Flying Horse North PUD/SP Amendment (Filing 9)
Preliminary Drainage Report Amendment

June 2026

PCD File No. PUDSPXXX

DETENTION BASIN OUTLET STRUCTURE DESIGN

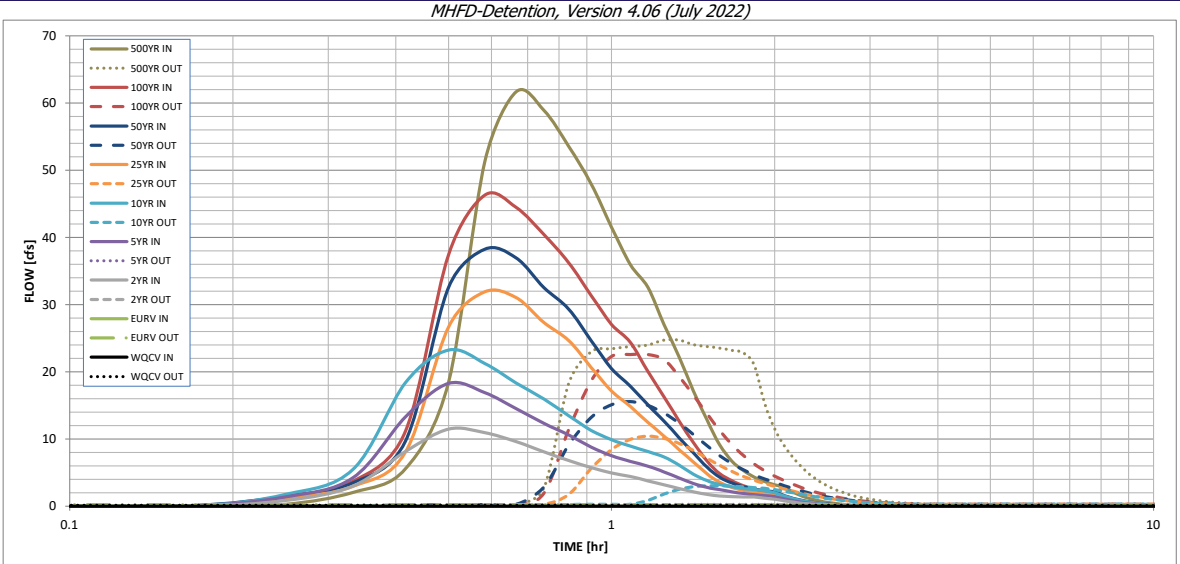
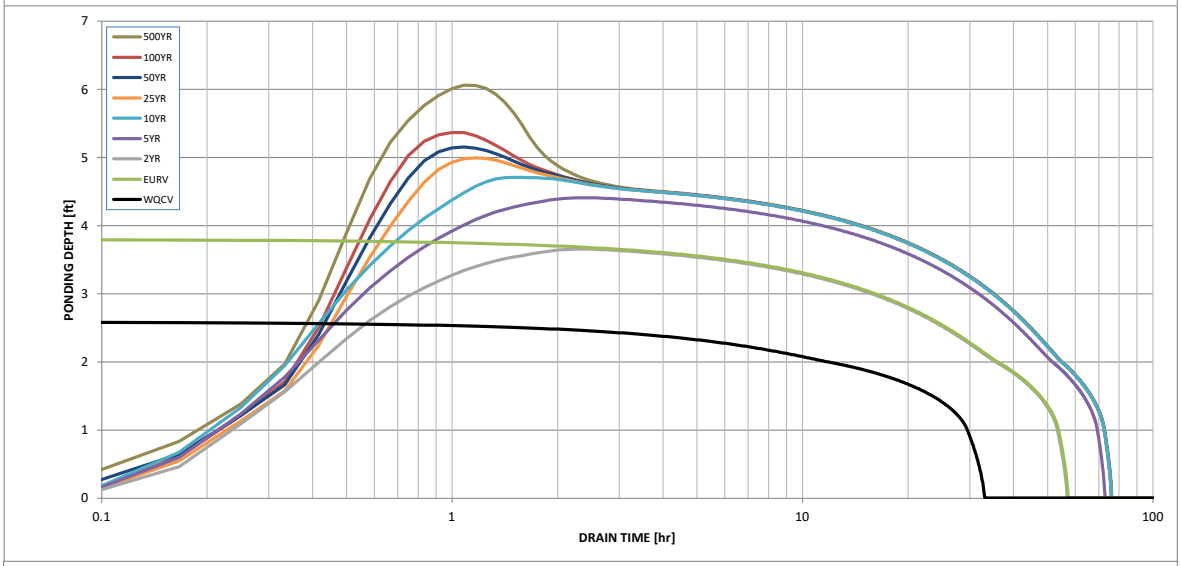
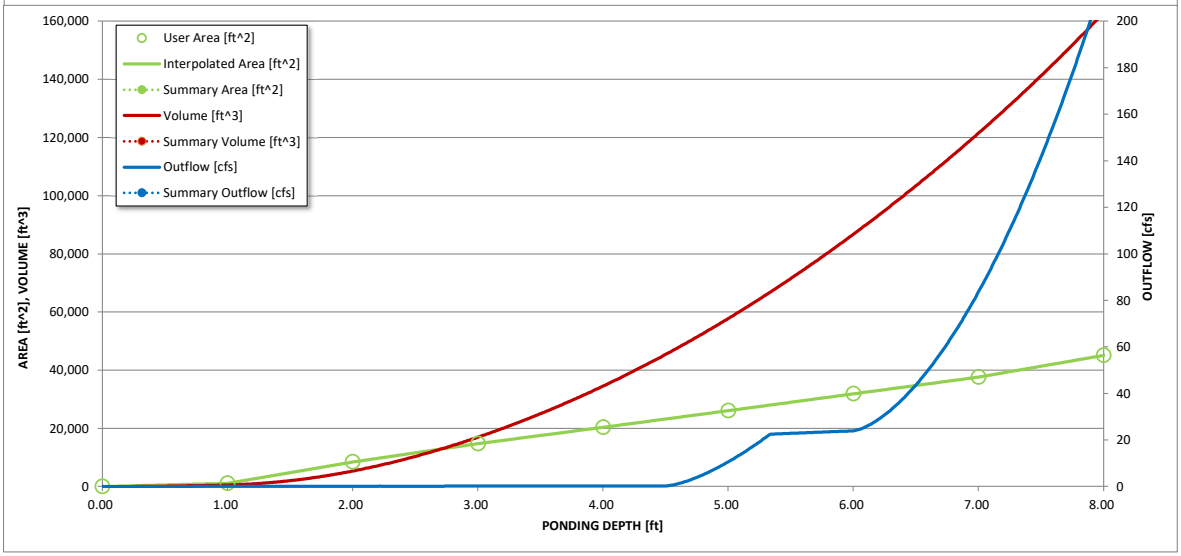
REQUIRES ORIFICE PLATE REPLACEMENT DUE TO ANALYSIS OF AS-BUILT BASINS IN THIS REPORT. SEE PROPOSED POND A CONDITION.

SHEET DR01 | 01

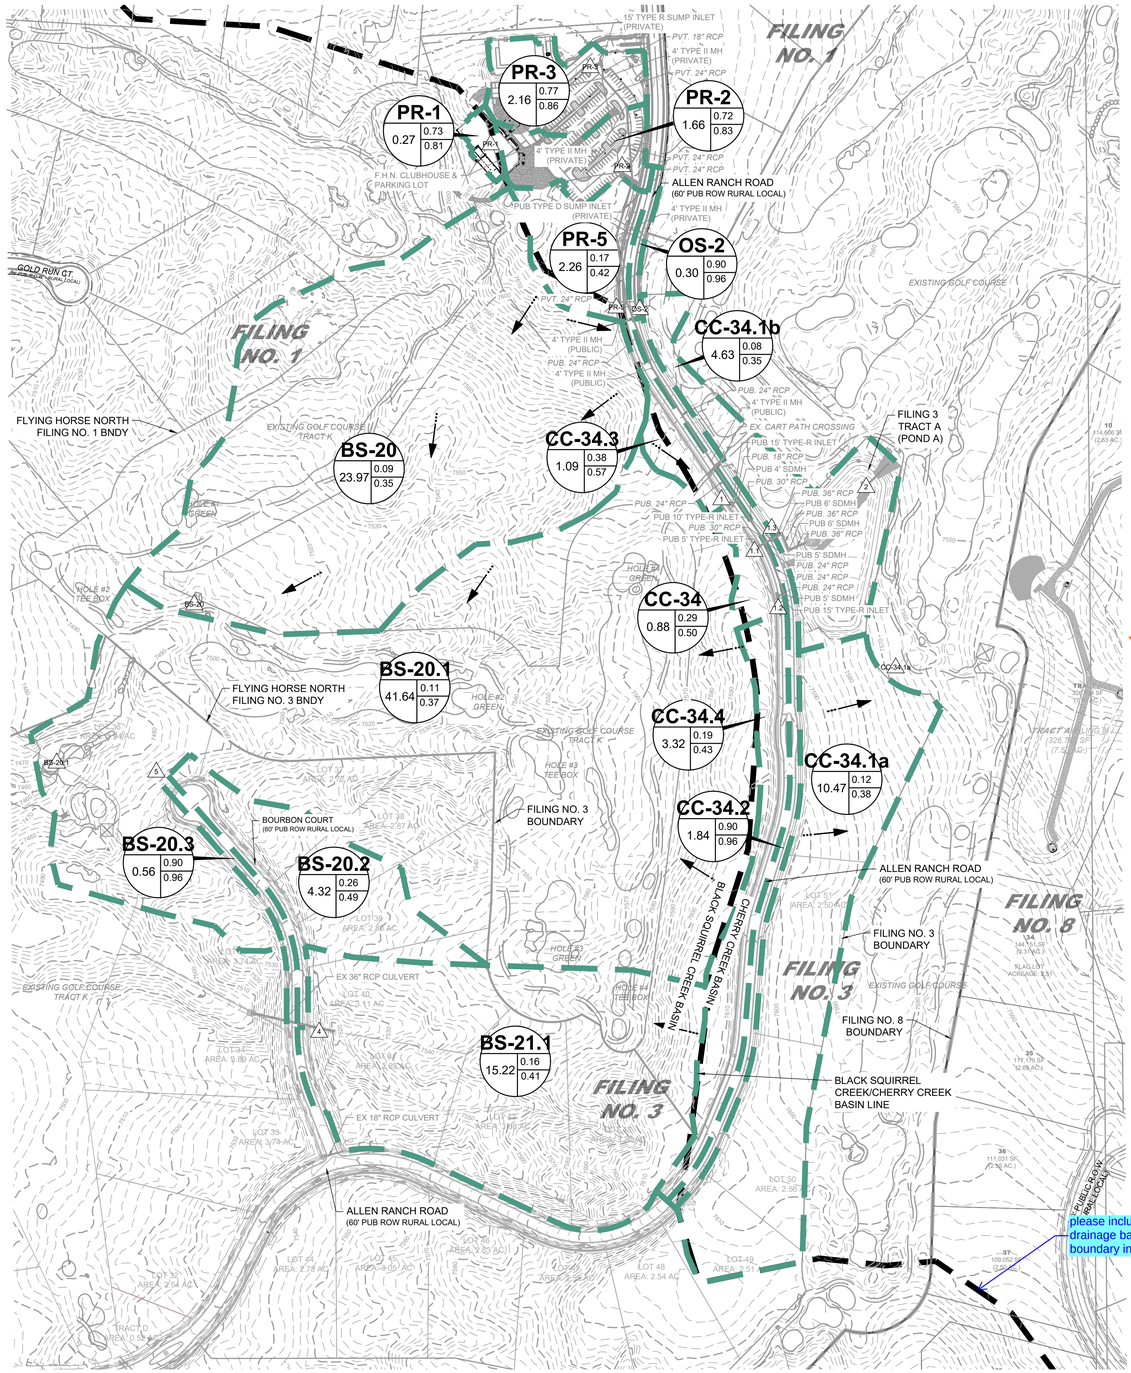
please show and label Filing No. 9 on this map

please include the drainage basin boundary in the legend

Now shown and labeled.

Added to legend

SHEET DR02 | 02

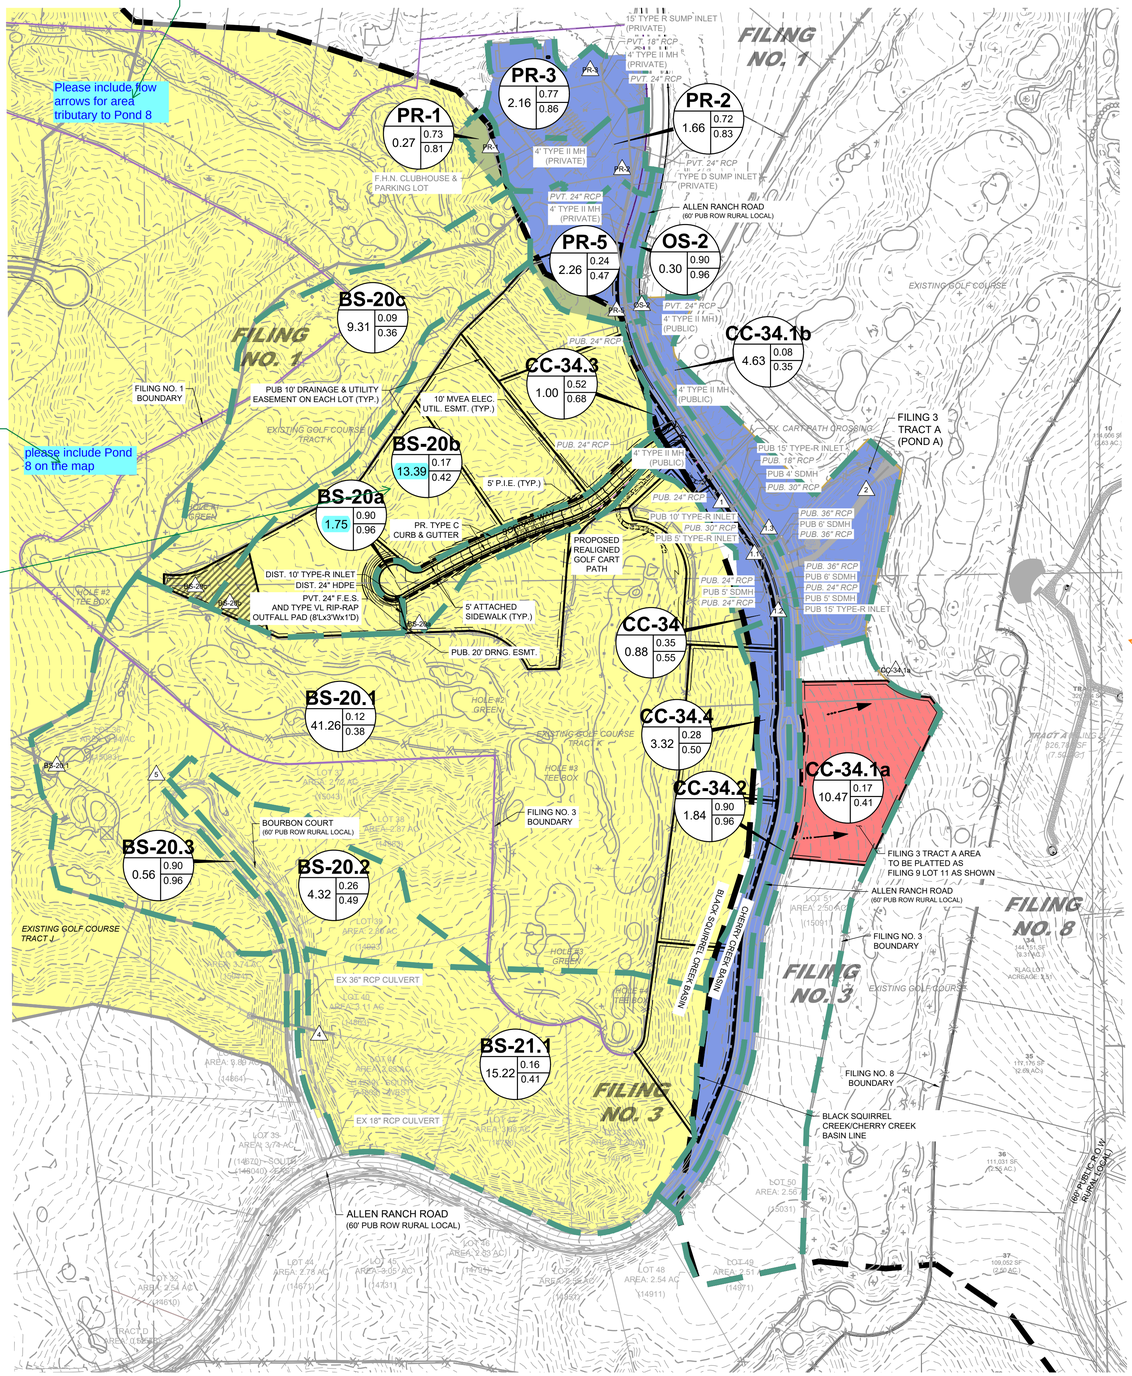
Please include flow arrows for area tributary to Pond 8

Added flow areas.
